**Re: GCC Rio Grande, Inc. - DRMS Permit No. M-2002-004, Revision No. AM-1
Exceedance of Groundwater Numeric Protection Levels**

GEOLOGIC REPORT AND SUBMITTAL

SUBJECT: A submittal in response to the letter by Division of Reclamation, Mining and Safety (DRMS), dated 29 November 2012 regarding: Pueblo Cement Plant and Limestone Quarry, Permit No. M-2002-004, Exceedance of Groundwater Numeric Protection Levels.

PLANT SITE GEOLOGY
GEOLOGIC STRAT. COLUMN

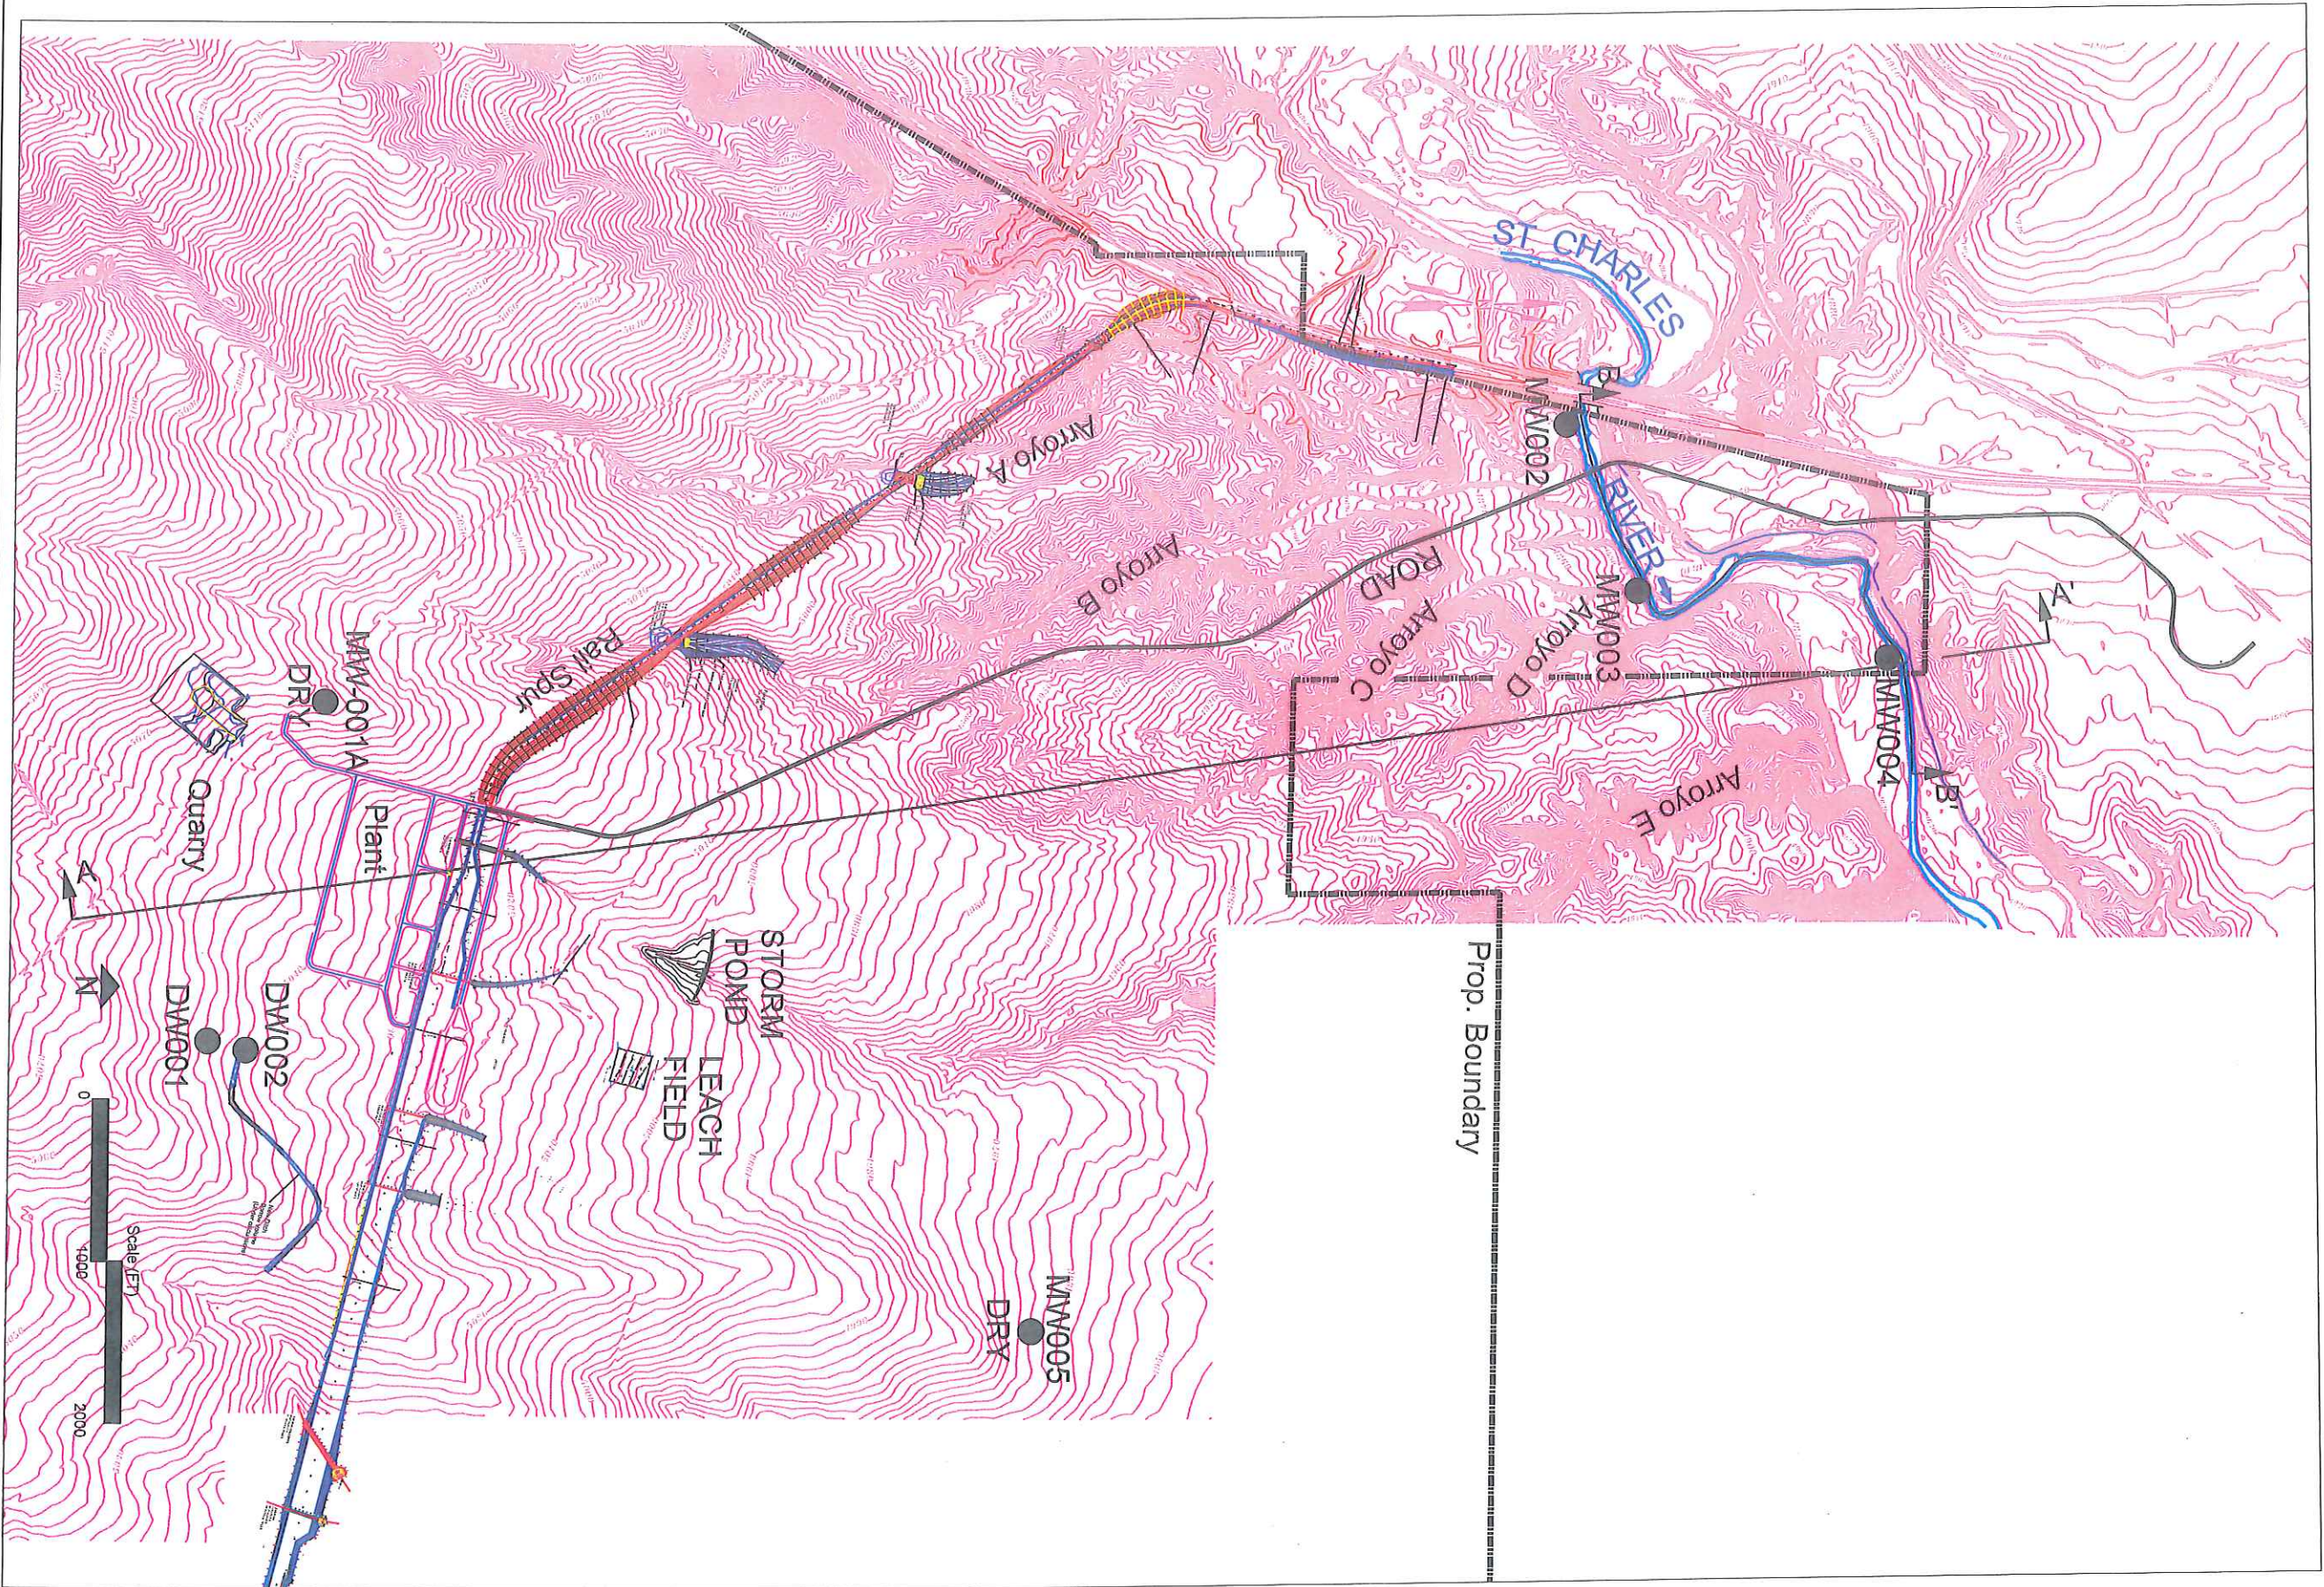
- a) *Extends through the cement plant/quarry area, monitoring well MW-004, and the St. Charles River.*

Response: Figure G1/G1A presents the surface geologic map and accompanying stratigraphic section description (Scott, Glenn R, Geologic Map of the Southwest and Southeast Pueblo Quadrangles, Colorado, U.S. Geological Survey Miscellaneous Investigations Series Map I-597. Scale 1:24,000, 1969) for the GCC property and surrounding area. Figure G2 presents the surface topography for the same map area. Both figures show section line A-A', which runs from the plant and quarry area, through well MW-004, and across the St. Charles River, and section line B-B, which runs through the three alluvial monitoring wells along the St. Charles River. Monitoring wells MW-001 through MW-005 are shown on the Figures. The figures also identify the locations of Arroyos (A through E), the rail spur, the cement plant and quarry, the storm-water retention pond, and the leach field.

MONITOR WELLS GEOLOGY
A-A' Cross Section

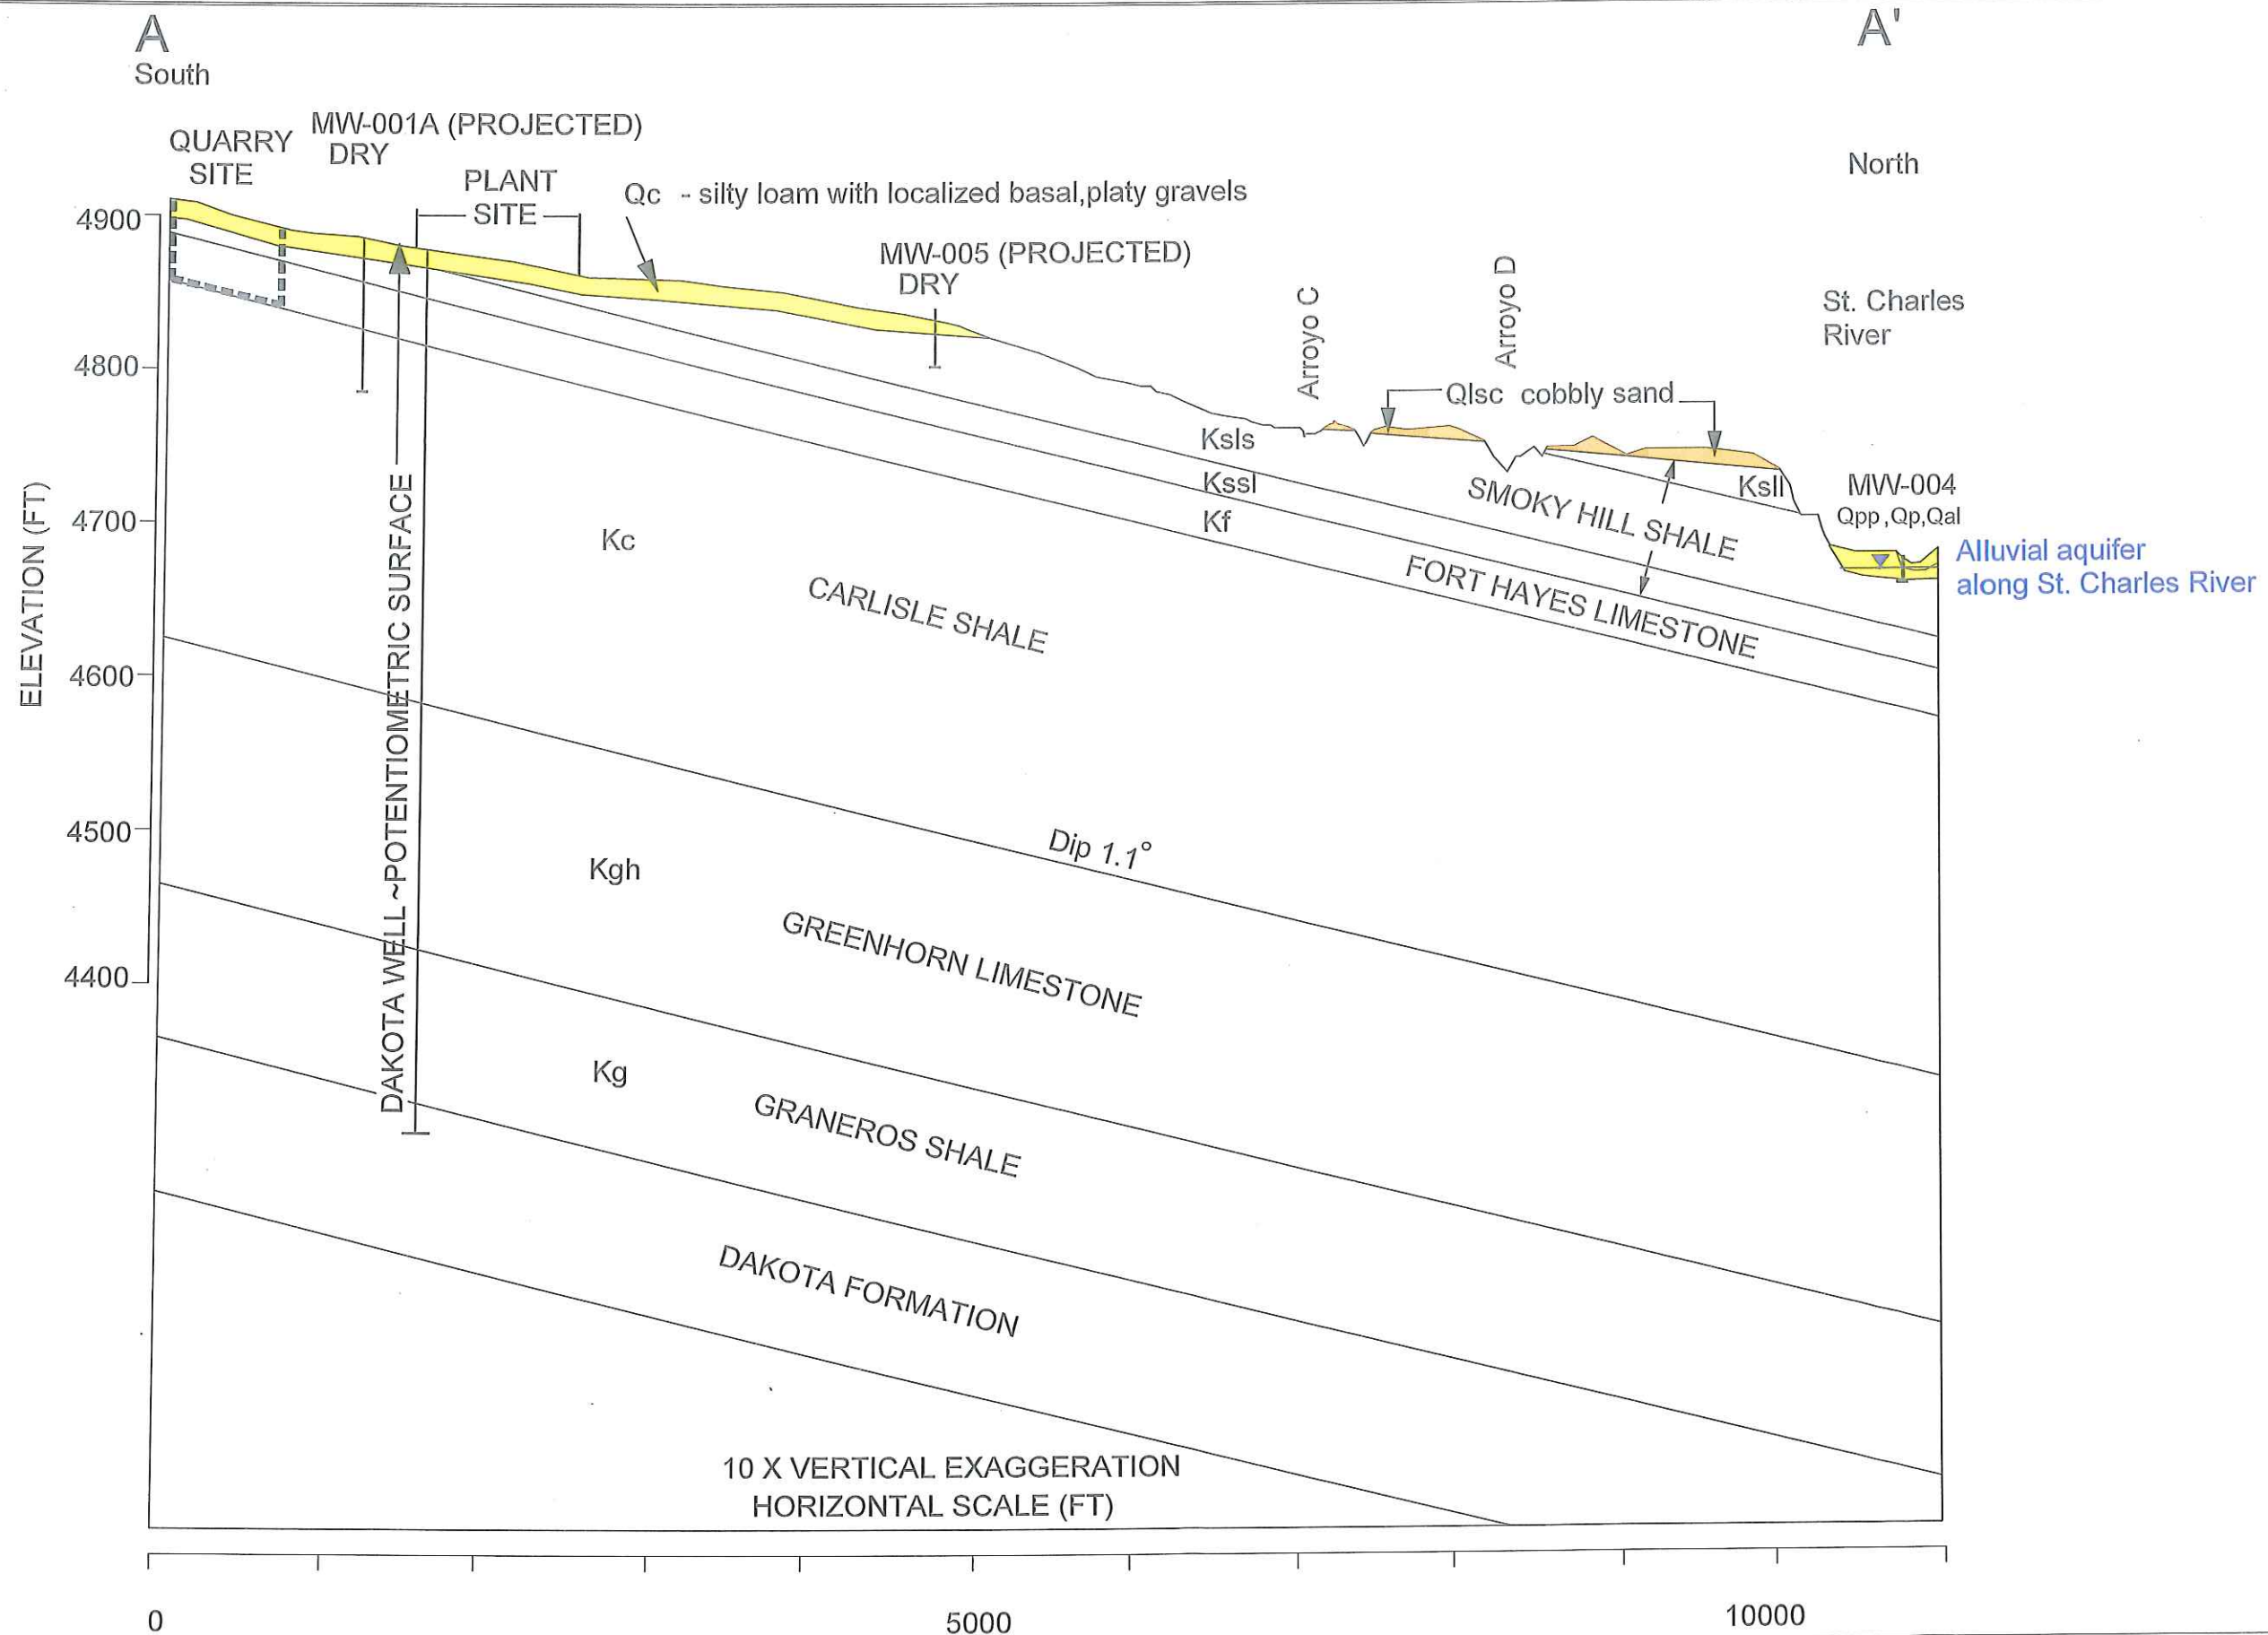
- b) *Shows the inferred geology in the cross-section to a depth that is at least as deep as the total depth of the deepest monitoring well associated with permit M-2002-004.*

f) *Shows the inferred potentiometric surface in the confined hydrostratigraphic units*

g) *Shows the water table in the unconfined units,*

Response: Figure G3 presents the inferred site geology in section view looking west across section A-A' shown in plan view Figures G1 and G2. The deepest Dakota formation production well associated with permit M-2002-004 is shown in the section. Wells MW-001, MW-004, and MW-005 are projected onto the section. The locations of Arroyos C and D, are projected onto the section, as well as the location of the St. Charles River. Unconsolidated Quaternary alluvial and colluvial strata are shown on the figure in yellow and orange.

Response: There are two production wells (DW-001 and DW-002) installed at the facility that penetrate the Dakota Sandstone. The general location and depth of these wells is projected onto the section in Figure G3. The source of groundwater and head in these wells is the Wet Mountains, located approximately 20 miles west of the GCC site. These wells are confined, and would flow under artesian conditions, if they were not capped. The potentiometric surface (head) of these artesian wells has not been determined.

Response: The only water table documented in the unconfined units is the alluvial water table in the St. Charles River drainage, as shown in Figure G3.

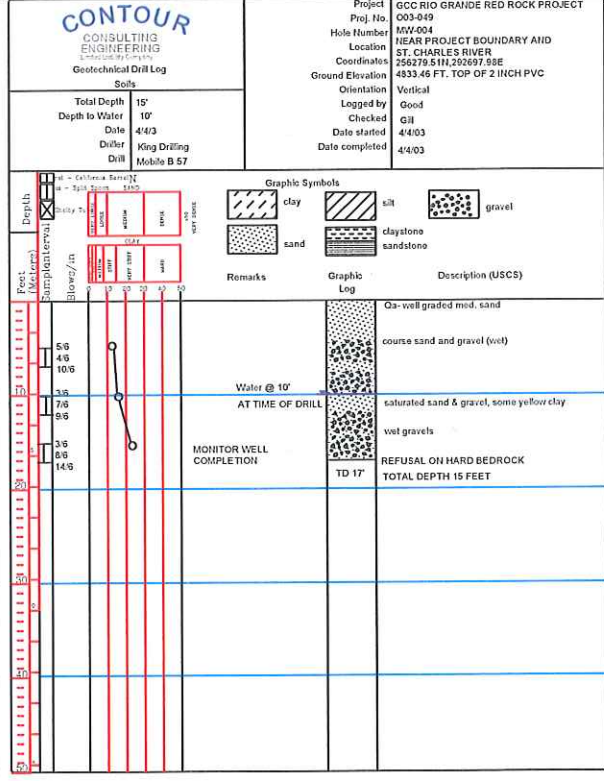
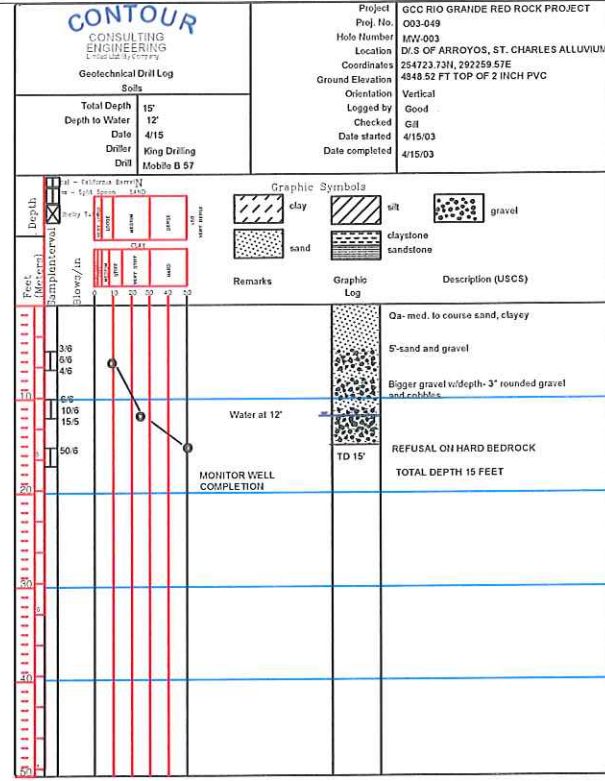
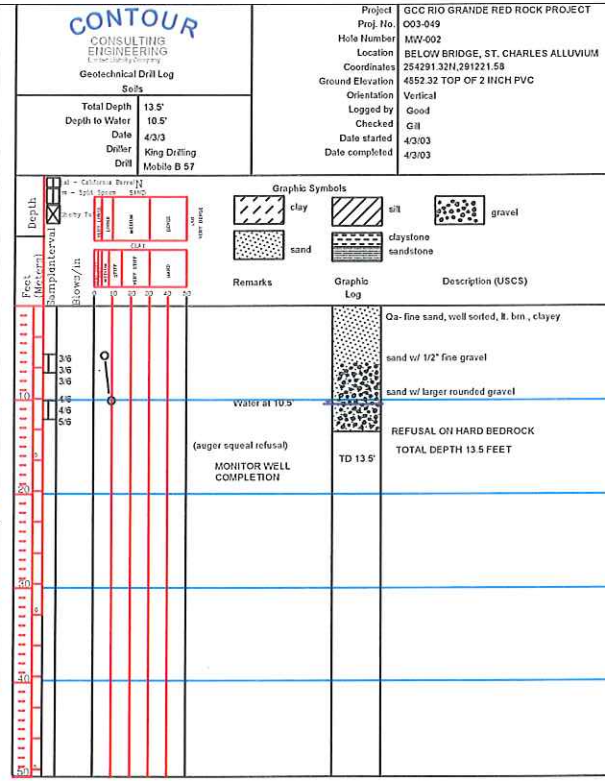
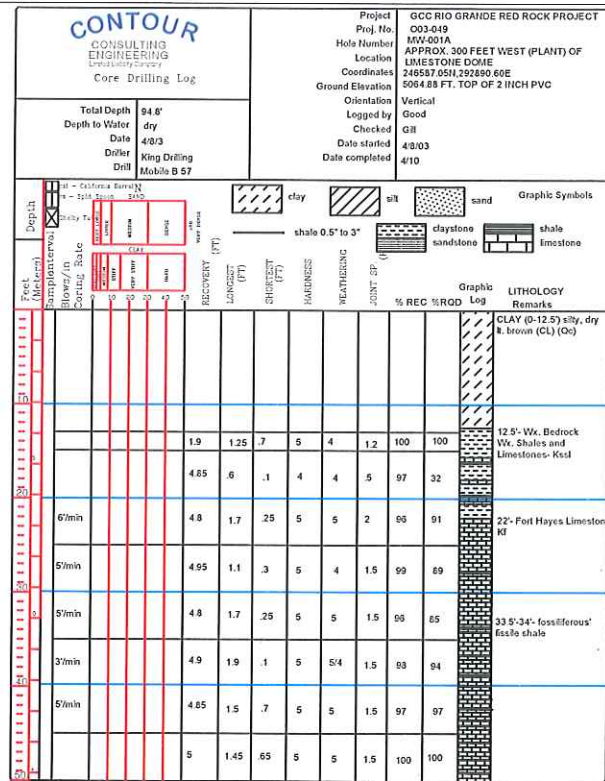
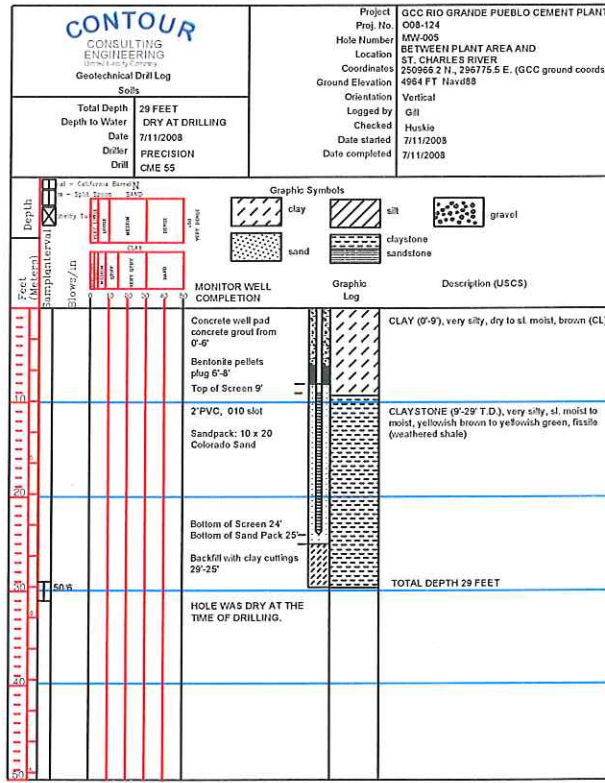
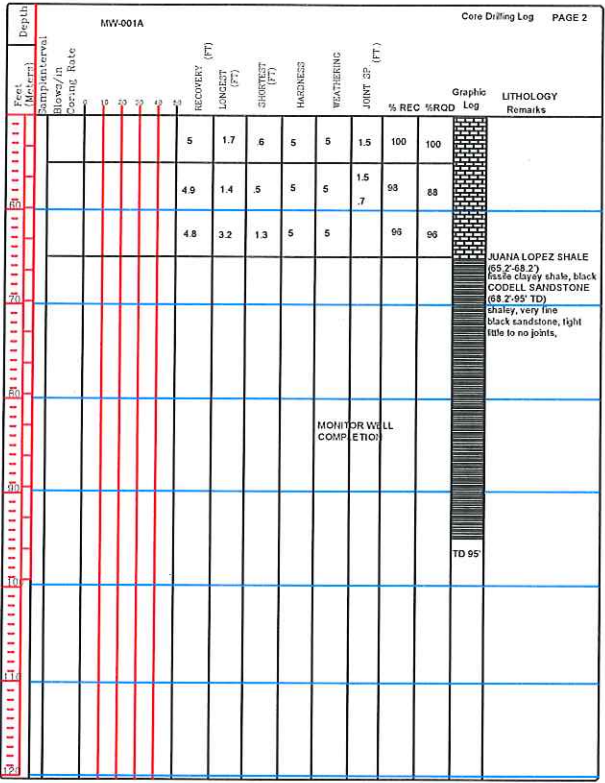
c) *Shows the completion interval of well MW-004*

Response: Completion details for well MW-004 and all monitoring wells are shown in Figure G-4.
